Plant Specific Details Regarding  
ATWS Mitigation System Actuation Circuitry (AMSAC)  
For Millstone Unit No. 3

April 1988

PLANT SPECIFIC DETAILS REGARDING  
ATWS MITIGATION SYSTEM ACTUATION CIRCUITRY (AMSAC)  
FOR MILLSTONE UNIT NO. 3

**FIGURE 5**

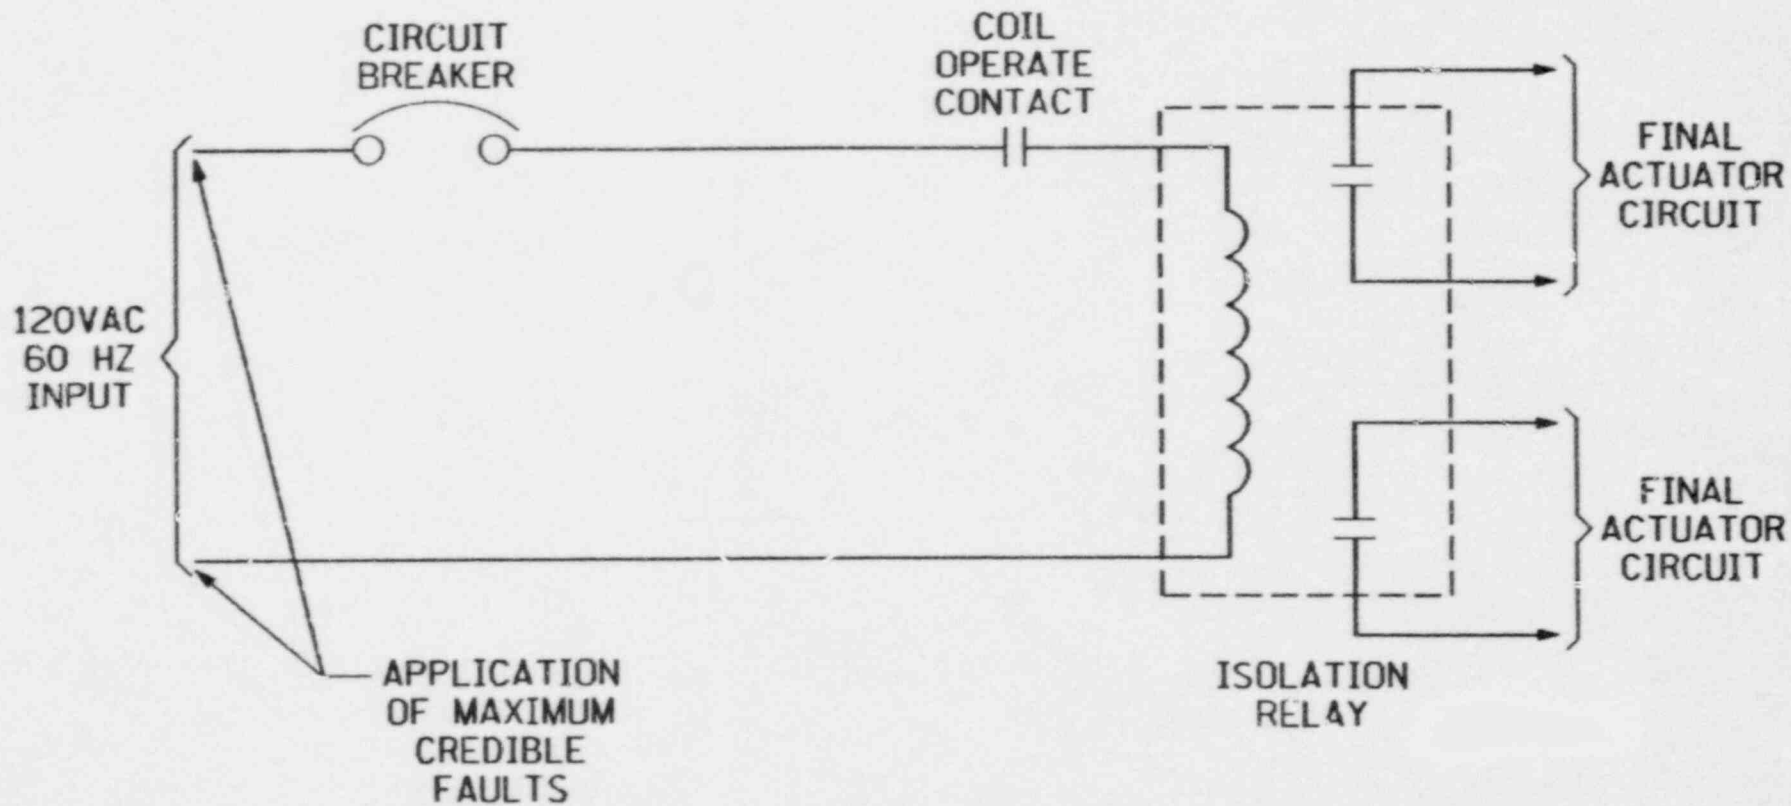
Relays are provided at the output of AMSAC for isolating the non-Class 1E AMSAC circuits from the Class 1E final actuator circuits. For Millstone, the AMSAC outputs are provided from separate relay panels within the AMSAC cabinet. Separation of the Train A, B, and Non-Class 1E circuits within the AMSAC cabinet is achieved through a combination of metal barriers, conduit, and distance. These relays have been tested with a maximum credible fault applied to the relay coil in the transverse mode. Tests have been performed with the relay coil operating contact in both the open and closed position. Figure 5 depicts the simplified diagram of this output isolation circuit, and point of application for the maximum credible faults. Details of the actual tests, fault levels and their origin, test data, and the pass/fail acceptance criteria will be submitted in the AMSAC Equipment Qualification Report.
